Sub. :- Diversion of 6.295 ha of Reserved Forest land in favour of MSRDC, Mumbai for Rehabilitation and Up-gradation of Pahur-Jamner Bodhwad-Muktanagar-Barhanpur NH-753L (Km 0+000 to Km 78+145) to two lane with paved shoulder in Villages-Jamner & Sonari, Taluka-Jamner, District- Jalgaon in the State of Maharashtra.

Reg. Compliance of Stage- I of Forest Proposal and request for according Final Approval (Stage- II) and working permission.

Query Compliance of Stage-I

In the preliminary scrutiny of the proposal of diversion of 6.295 Ha Jalgaon for construction of the newly declared NH Pahur-Bodwad Road (NH-753L) following points raised while scrutinized the above proposed. The compliance of the shortcoming & submitted with relevant documents as follows :-

TITLE: PLAN AND PROFILE
DETAILS: PLAN AND PROFILE (CH-22-00 TO 23-00)
DATE: 25-07-2019
SCALE: As shown
DRAWING NO: 001/PATJAM/PP-13
SHEET NO: 15/15

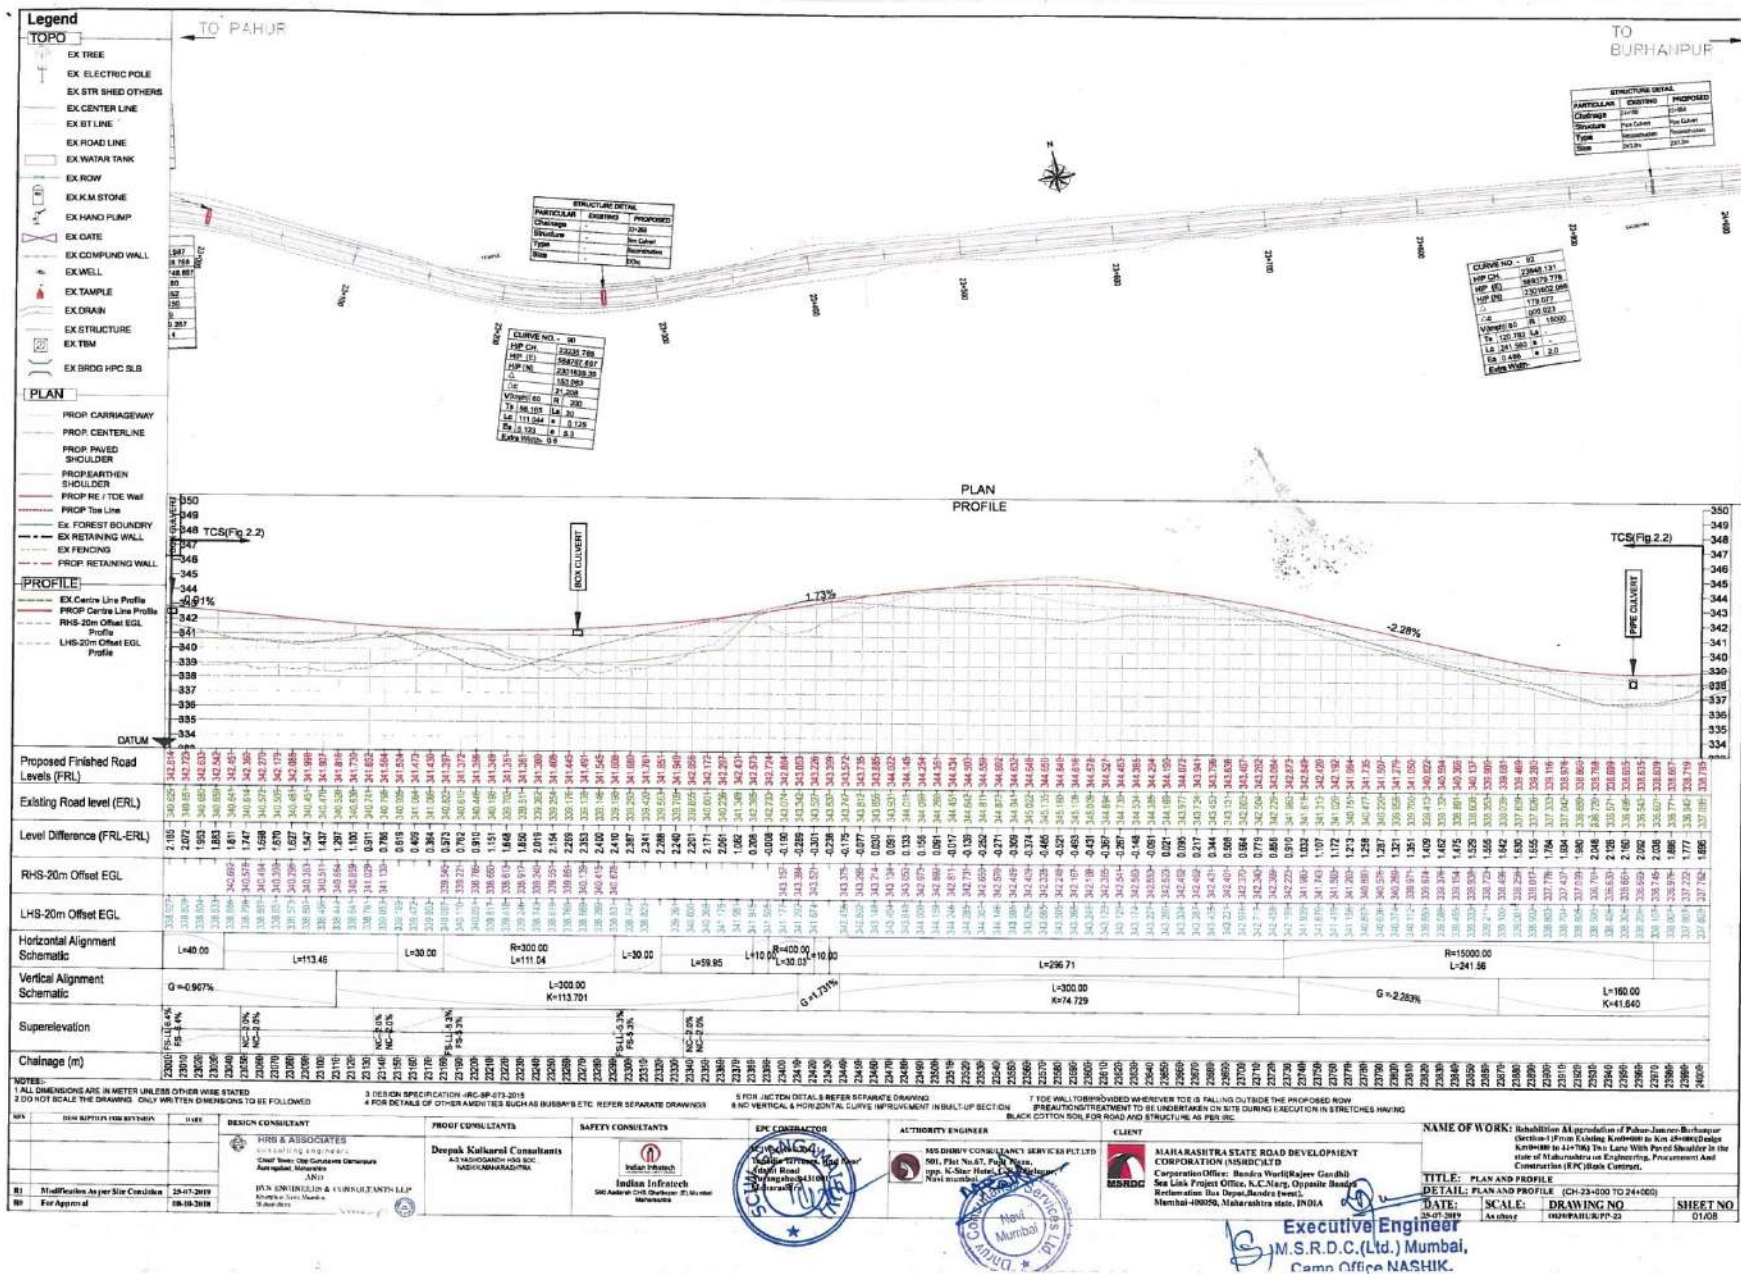
2.	Exact details of the realignments in the forest area along with the details of the left over forest area shall be submitted.	Details of realignment in the forest area is attached herewith.

TYPICAL CROSS SECTION-2.2_B

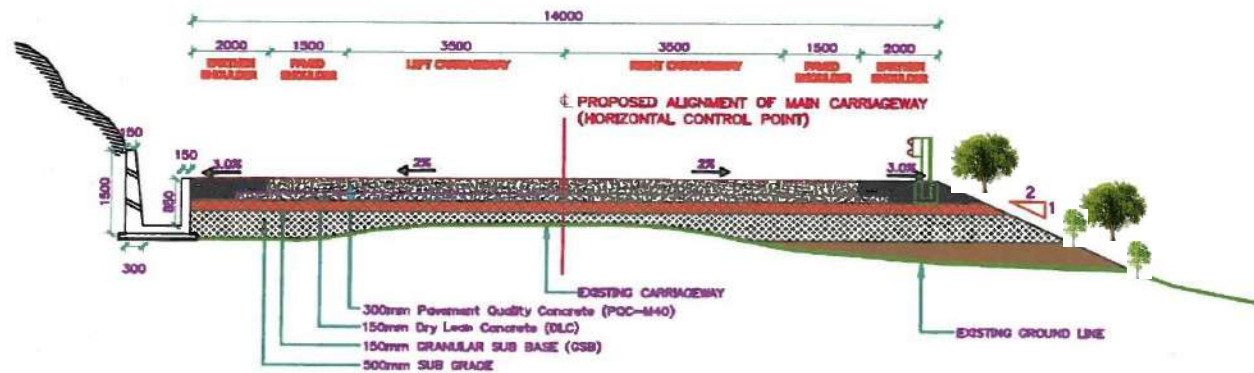
Query No. 3: Cross section map of ROW proposed in the forest area and non-forest area is as follows.

As per contract agreement.

Proposed typical cross section of road in Forest area

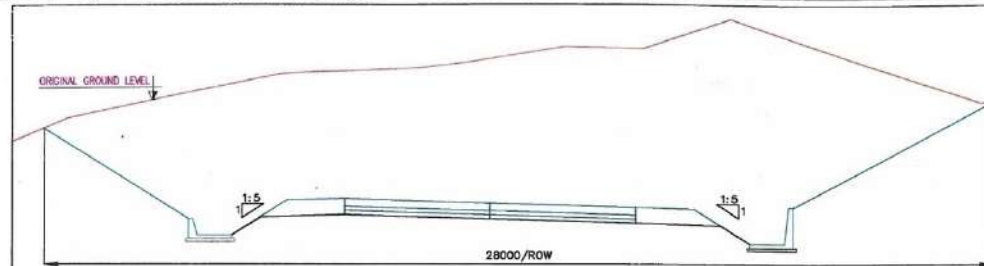
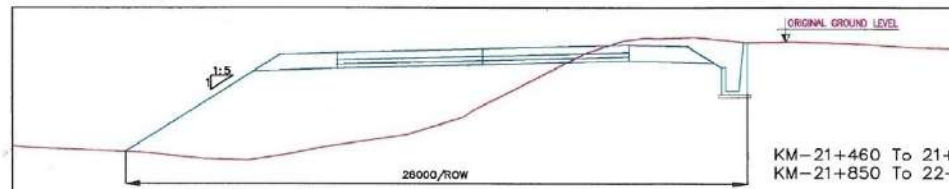
3.	Cross section map of the RoW proposed in both forest and non-forest area needs to be submitted.	Cross section showing proposed ROW in forest and Non Forest area is attached herewith.
